INSTRUCTION TO SERVICE

ITS: 5481

SECTION:	231 Coolant System
WRITTEN BY:	Mike Pearson
SUBJECT:	Rework OK6 Transmission Cooler Wire Harness UV Damage

Figure 2: EMP Rooftop Transmission Oil Cooler Main Harness Layout

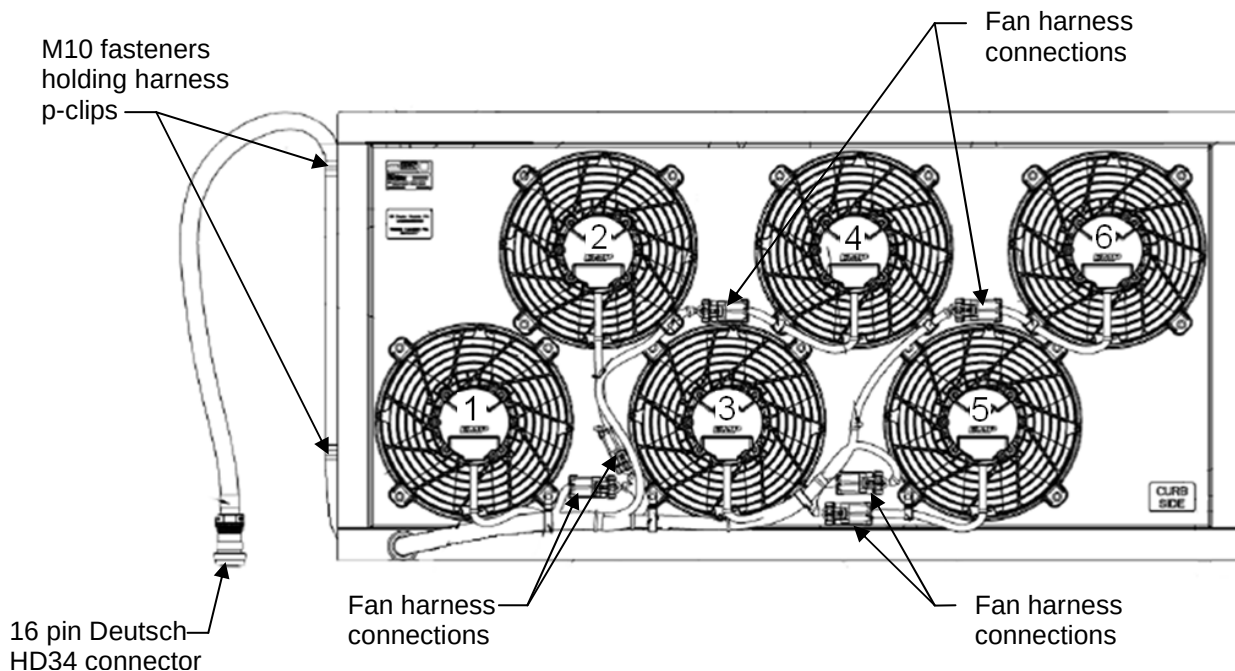
6. **Main Harness Removal:**
 - a. Disconnect the 16 pin Deutsch HD34 connector from the bulkhead connector on the driver's side of the bus. This requires a twisting motion in the counterclockwise direction.

- b. Remove the two M10 fasteners attaching the main harness p-clips to the oil cooler frame. These are on the driver's side of the Kit. Reserve the fasteners for reassembly.

- c. Disconnect each of the fans from the main wire harness by depressing the locking tab and pulling back on the harness connector body, pulling the connector body off the shroud.

- d. Cut and remove the cable ties attaching the harness to the shroud in each of the two locations; between fans 1, 2 and 3 and between fans 3, 4 and 5.

- e. Remove the main harness from each of the 8 J-clips by bending the J-clips away from the fan shrouds they are attached to. Discard the removed harness.

Figure 3: Close Off Plate Locations

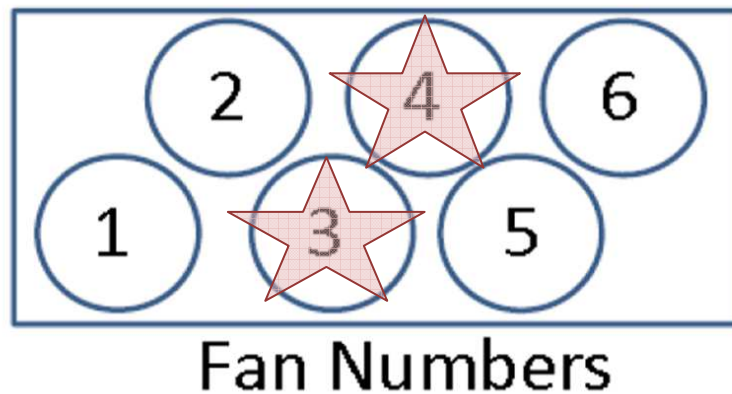
- a. Install the 2 closing plates at the locations shown in Figure 3 in place of fans 3 and 4.

Fig. 6b: Seal Visible, Incorrect

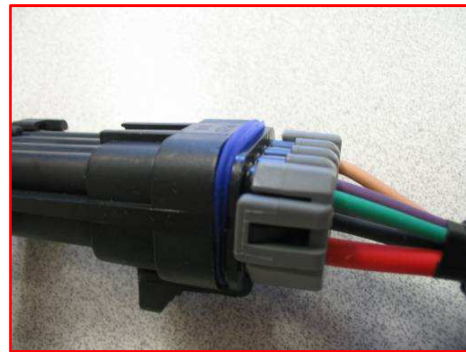
NOTE: When connecting Main Harness to Fan Harness, the connector is seated when you will hear or feel a “click”. Make sure the seal is not visible. If there is blue seal visible after the connector is seated then the connection will not be sealed and be compromised (Figures 6a and 6b).

SUMMARY IMAGES:

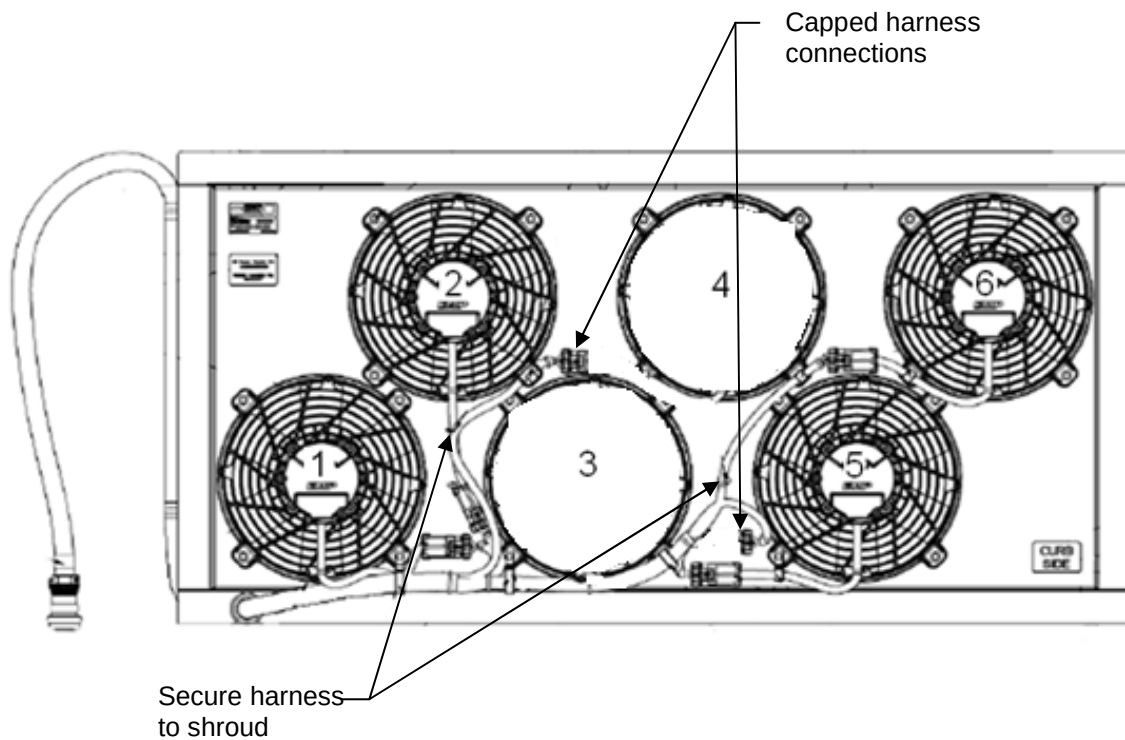
After more in-depth analysis of new production and to improve the overall simplicity of the system, New Flyer and EMP have determined the cooling demand only requires 4 fans, versus the current 6 fan setup. As a result, starting in year 2014 New Flyer production will only have a 4 fan system.

To remove the risk of having inoperable fans, the OK6 main harness will be replaced on subject units; the existing 6 fans will be replaced with 4 new or reworked fan assemblies depending on the severity of damage, 2 cover plates and all necessary hardware for the rework.
